Re-submittal Form

RESUBMITTAL CONTENTS

VIP PARKING
 23905 EAST 26TH AVENUE
 AURORA, CO

SITE PLAN

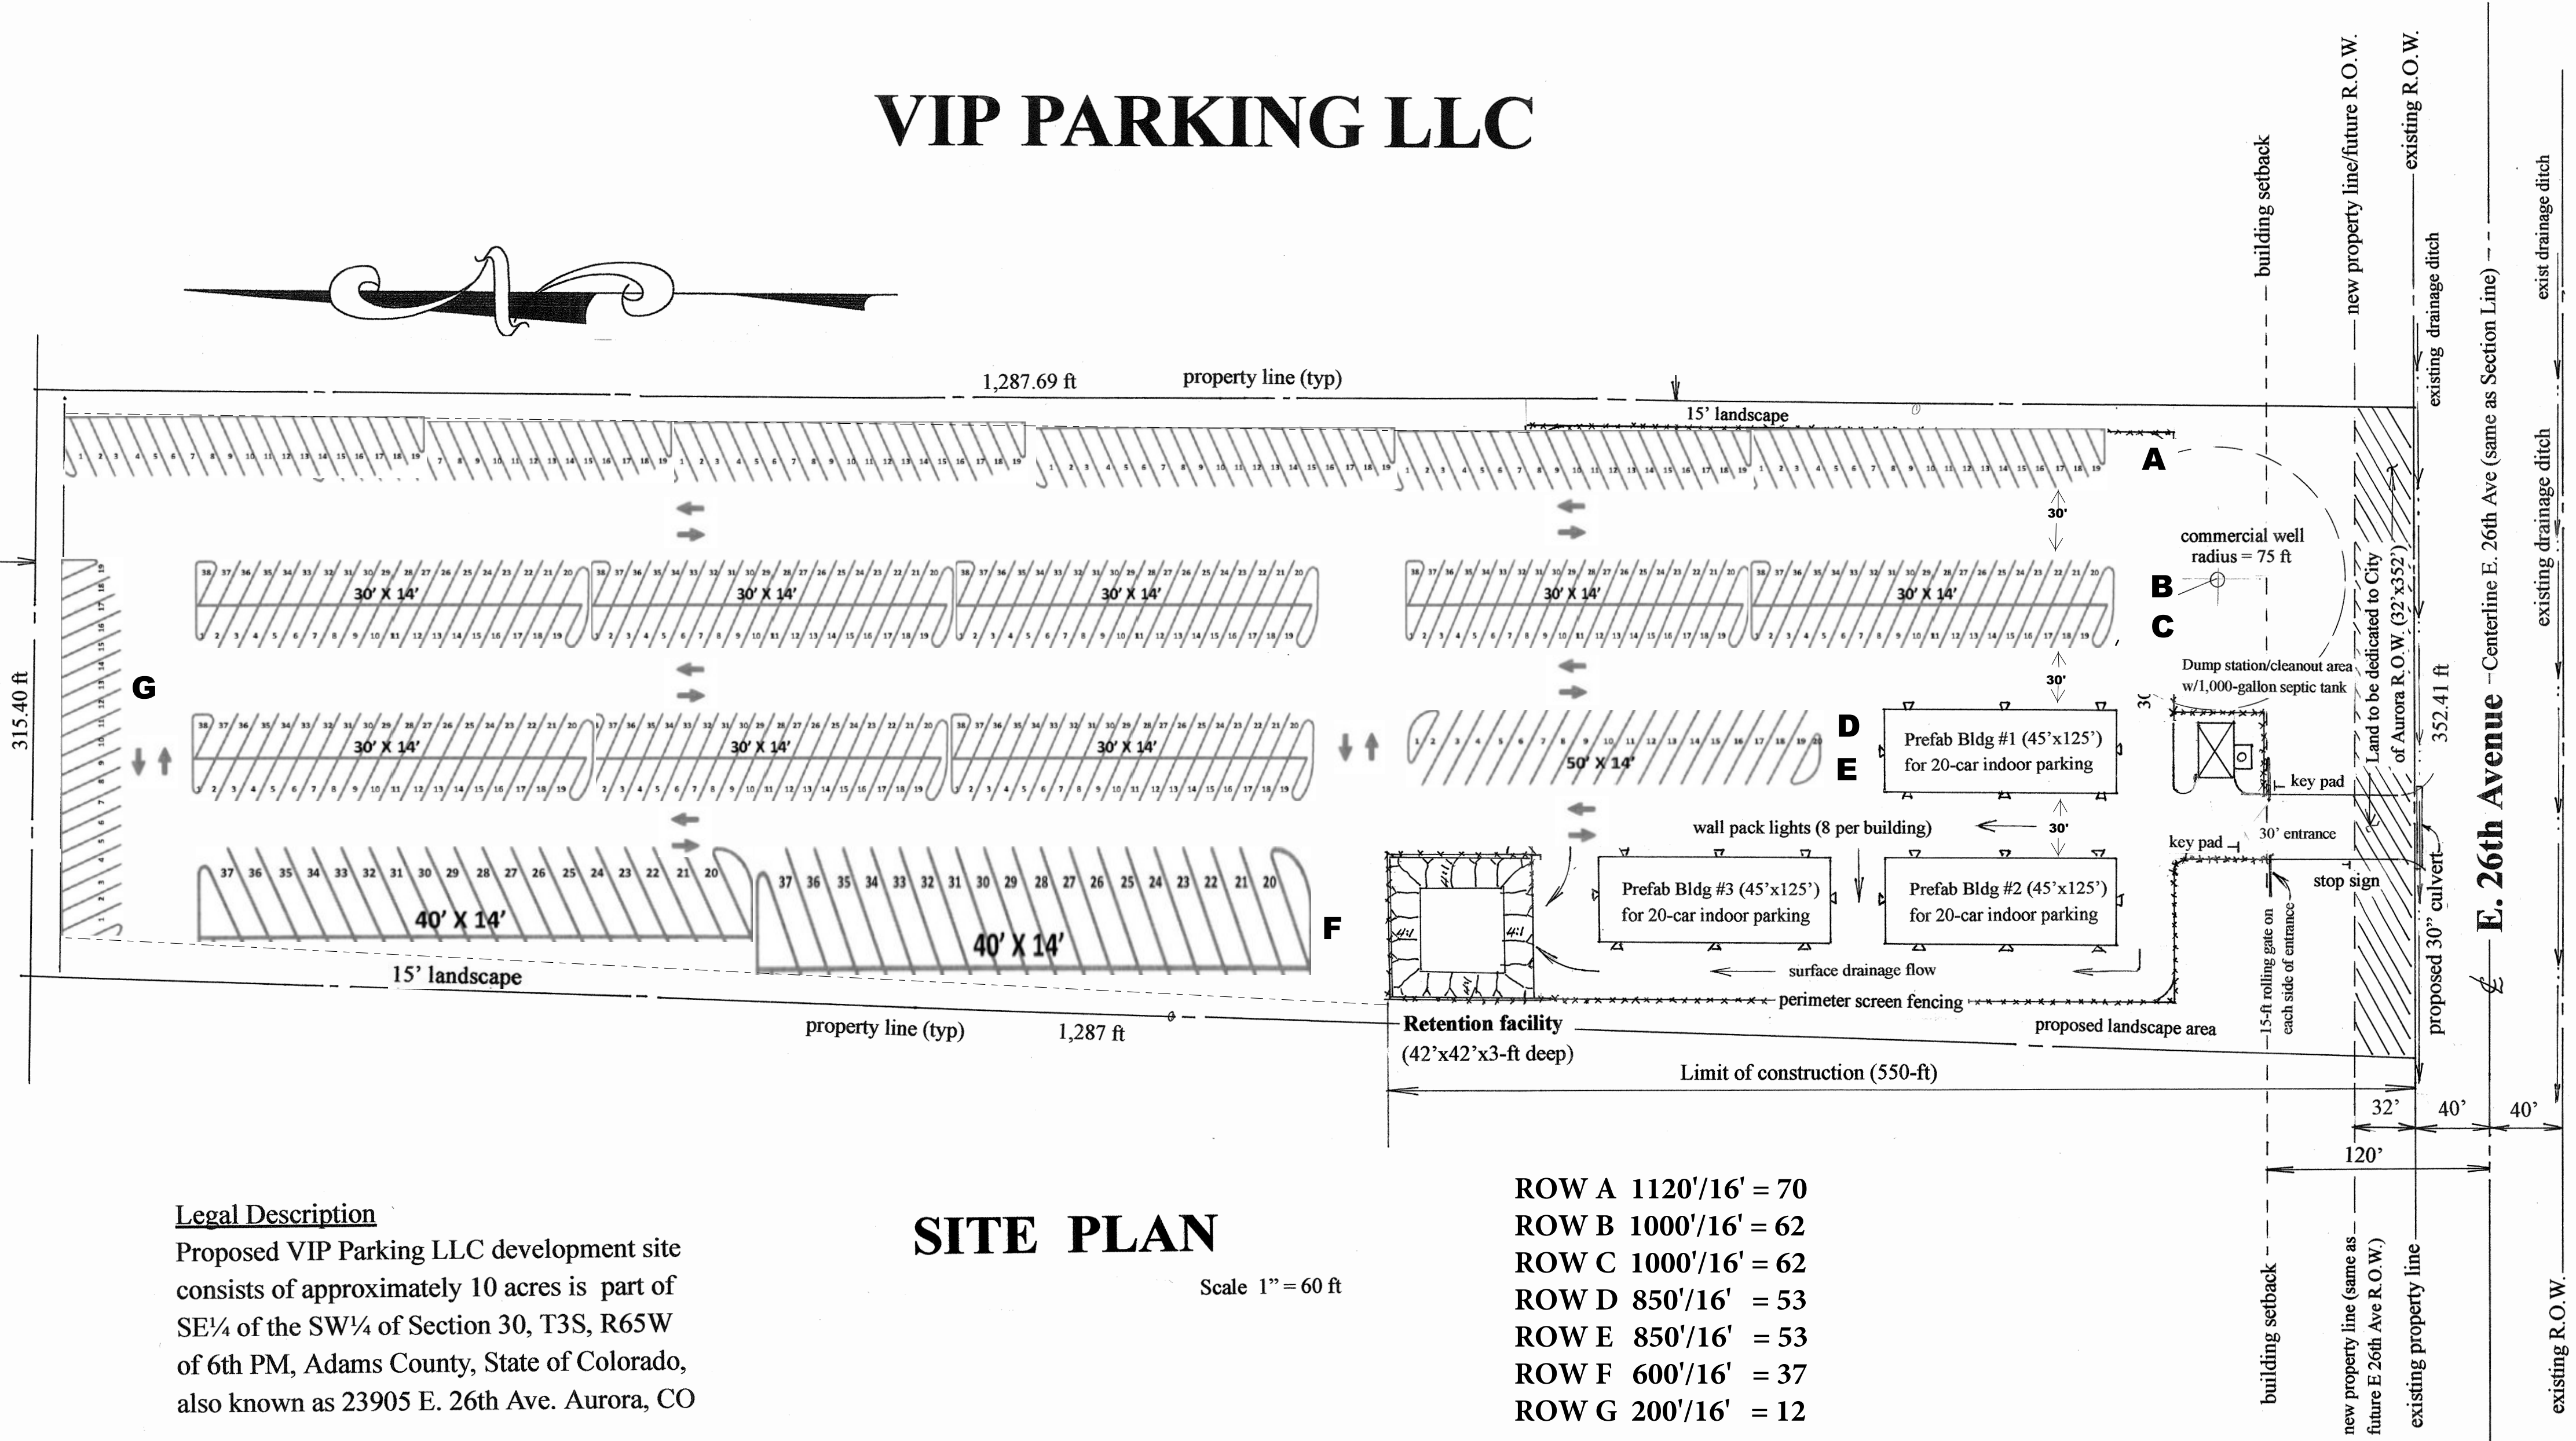
PLN 04: Site Plan - need to see well and septic system. Is there trash?

ROW2: Need to show location of septic system and limits of leach field on Site Plan.

The dump station holding tank will be located just east of the driveway on the south end of the property. There is a commercial well, over 50' from the proposed holding tank. A restroom is installed with a men's and women's restroom. There will be a total of two toilets, two sinks and two drinking fountains.

The RV holding tank is a 2500 gallon monolithic concrete water tight tank, manufactured by Front Range Precast, in Boulder. The 2500-gallon size will minimize the frequency of pumping. However, frequency of pumping depends on the usage by customers and will be determined by the high-water alarm system described below.

A high-water alarm system to audibly and visually signal when the holding tank is 75% full is installed to warn that pumping the tank should be done.

Trash dumpster is located next to next to the RV dump station.

Please refer to Parking Lot/ Site Plan pg. 14 of this re-submittal for location of septic holding tank. There is no leach field.

STORM DRAINAGE SYSTEM DESIGN
(By RATIONAL METHOD)

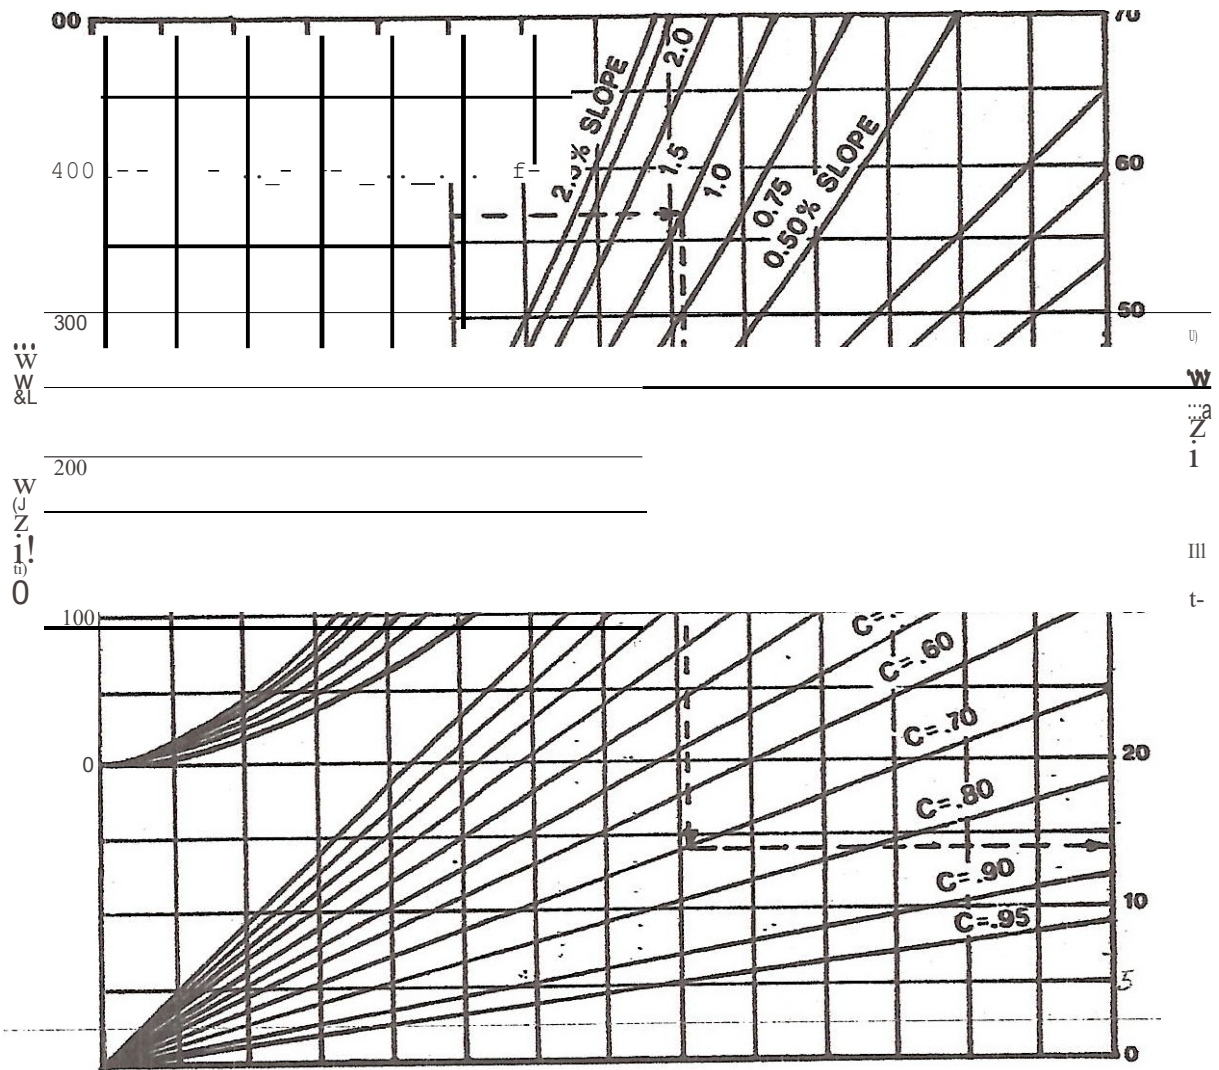
ENG6: The applicant is proposing to install over 3,000 square feet of impervious area on the project site, thus a Drainage Report and Drainage Plans prepared in accordance with Chapter 9 of the Adams County Development Review Manual, would be required to be completed by a Professional Engineer (P.E.)

Please refer to attached drainage report.

Compare net increase of runoff (before and after development)

$$\begin{aligned} \text{Net increase} &= (q1 - q2) \\ &= (12.2 - 4.48) \text{ cfs} \\ &= 7.72 \text{ cfs} \end{aligned}$$

$$\begin{aligned} \text{Equivalent vol @ } T_c &= 10 \text{ minutes min.} \\ &= 7.72 \text{ cfs X 600 seconds} \\ &= \underline{4,600 \text{ cu ft}} \end{aligned}$$

Required Detention Pond size:

- 40-ft by 60-ft by 3ft deep (included 1-ft free-board)
- 45-ft by 45-ft by 3ft deep (included 1-ft free board)
- or any other combinations
